Access Compliance Report

Public Rights-of-Way

Intersection ID: 10032880	Main Street: NATIONS_FORD_RD	Cross Street: N/A	Location: NW
ADA ID: E1094C3795C7	Ramp Type: ParaDiag	Initial Pass/Fail: Fail	Overall Compliance: No
Codes/Mitigation Info/Possible Solution		Field Measurements/Component Compliance	
Severity Score: 13.75

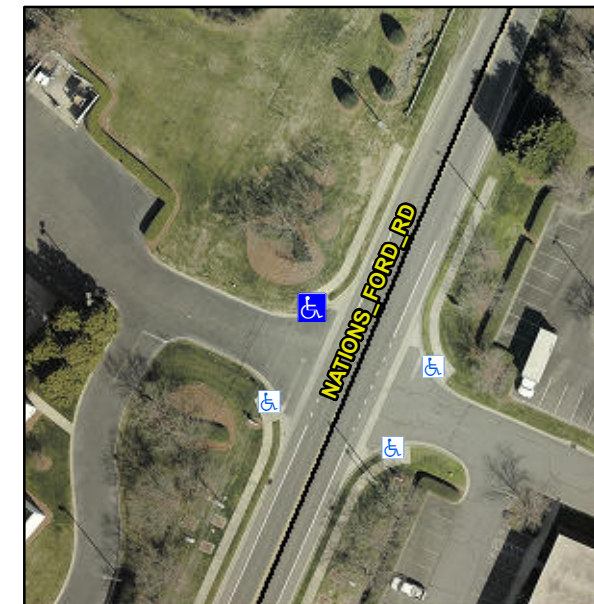
Remove & Replace Curb Ramp With Two New Directional Ramps or Equivalent.

R304.3.2, R304.5.3

Compliance	Description	Data	Compliance	Description	Data
N/A	Ramp Length LT (in)	51.0	N/A	Ramp Length RT (in)	64.0
Yes	Ramp Width LT (in)	108.0	Yes	Ramp Width RT (in)	108.0
No	Ramp Slope LT (%)	11.7	Yes	Ramp Slope RT (%)	3.0
Yes	Ramp XSlope LT (%)	0.4	No	Ramp XSlope RT (%)	2.6
N/A	Landing Length (in)	N/A	N/A	DWS Provided?	N/A
N/A	Landing Width (in)	N/A	N/A	DWS Contrast?	N/A
N/A	Landing Slope (%)	N/A	N/A	DWS Length (in)	N/A
N/A	Landing X Slope (%)	N/A	N/A	DWS Full Width?	N/A
N/A	Landing Curb? (Y/N)	N/A	N/A	DWS Offset (in)	N/A
N/A	Shared Landing?	N/A			
N/A	Gutter Ponding?	N/A	N/A	Gutter Slope (%)	N/A
N/A	Gutter Lip Ht (in)	N/A	N/A	Gutter X Slope (%)	N/A
N/A	Painted X Walk1?	No	N/A	Painted X Walk2?	No
	X Walk 1 Direction	To S		X Walk 2 Direction	To E
N/A	X Walk 1 Width (in)	N/A	N/A	X Walk 2 Width (in)	N/A
	X Walk 1 Slope (%)	5.4		X Walk 2 Slope (%)	1.3
	X Walk 1 X Slope (%)	1.2		X Walk 2 X Slope (%)	5.3
N/A	Ramp inside XWalk1?	N/A	N/A	Ramp inside XWalk2?	N/A
